SUBJ: PROPOSAL FOR SITE CHANGES

# PROPOSAL FOR CHANGES

.. SURVEY FOR ..

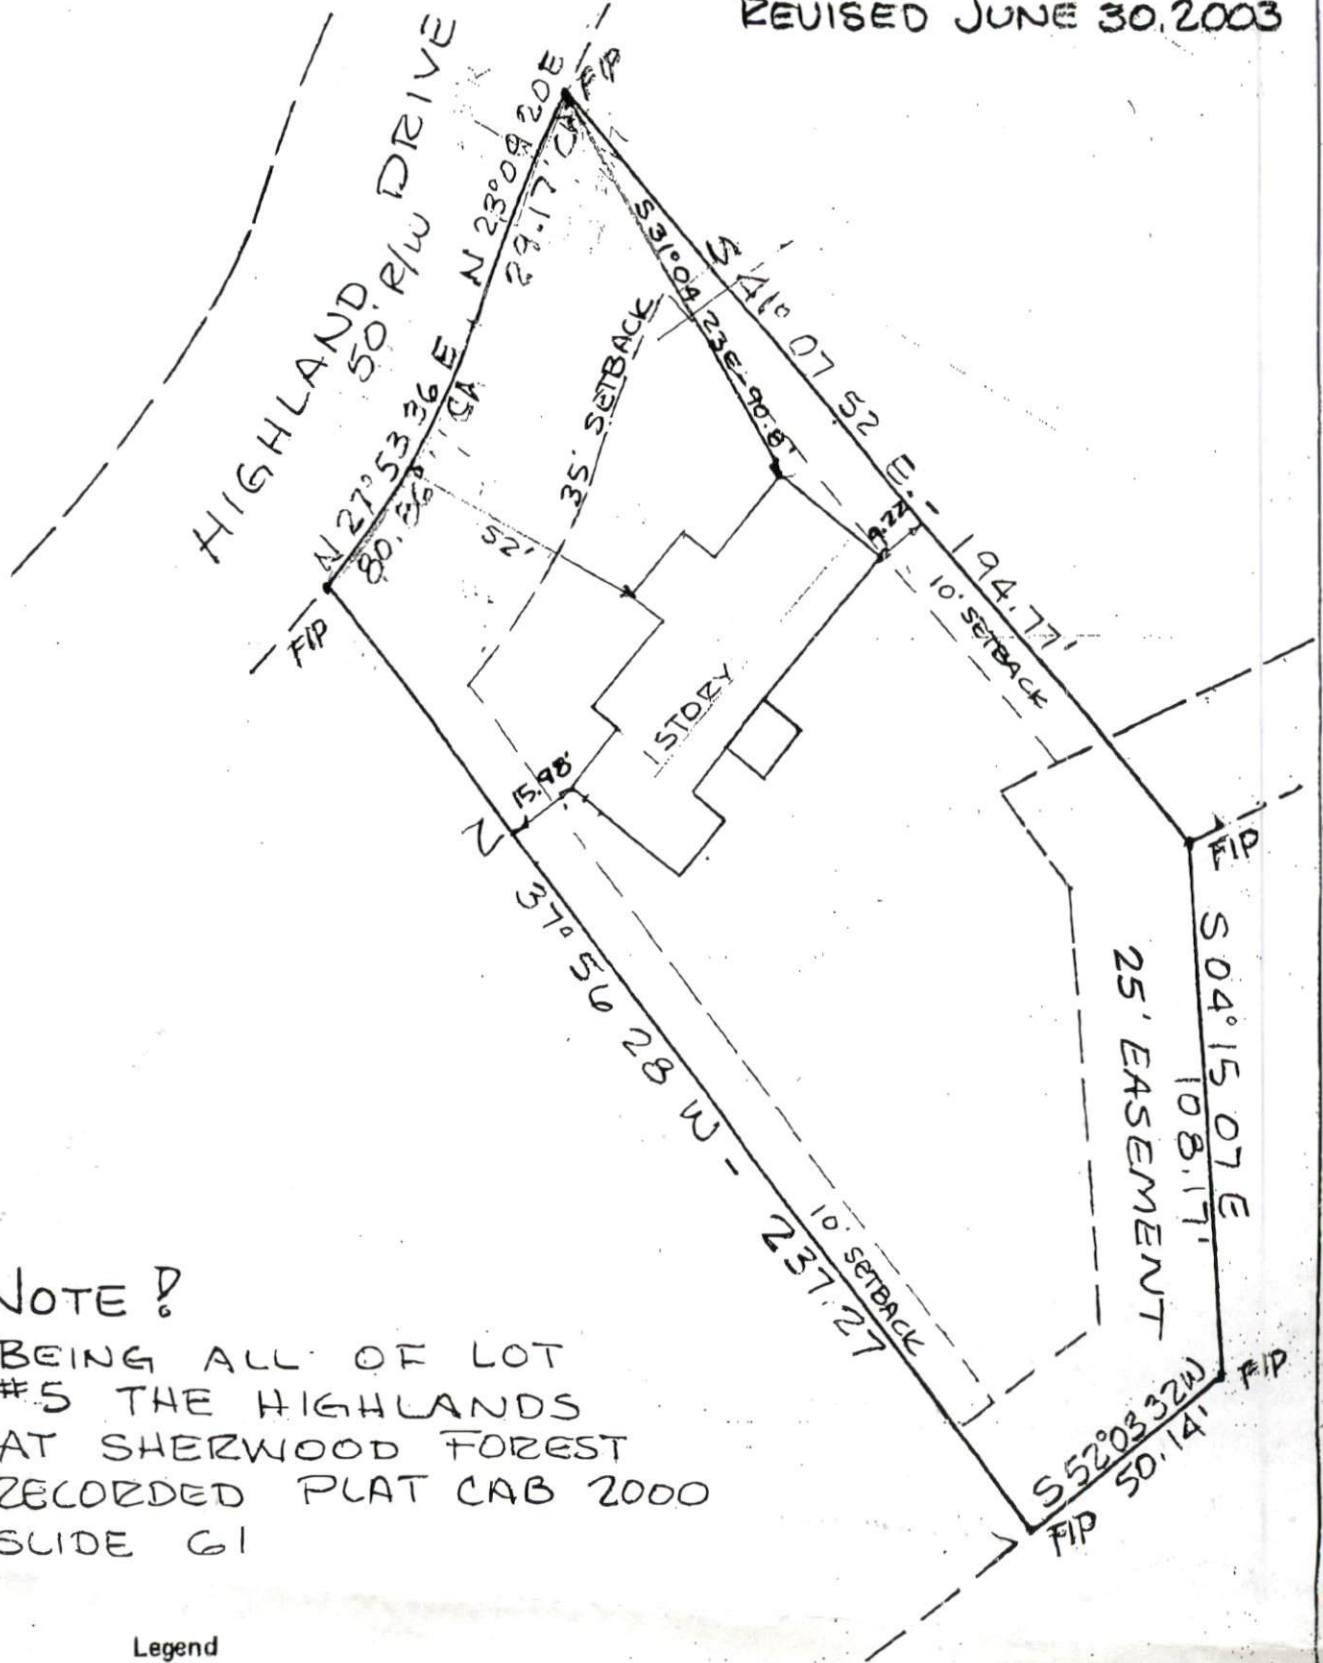
WE PROPOSE INSTALLING A NEW SEPTIC TANK AND DISTRIBUTION SYSTEM SOUTH AND WEST OF THE HOUSE. THE LOT HAS LESS OF A SLOPE ON THAT SIDE OF THE LOT. THE EXISTING TANK WOULD BE PUMPED OUT AND FILLED WITH SAND. THE EXISTING DISTRIBUTION LINES THEN WOULD BE ABANDONED IN PLACE.

WE ALSO PLAN TO BUILD A 2-CAR GARAGE WITH ROOM OVER SO I CAN HAVE A ROOM TO WORK ON MY ARTWORKS.
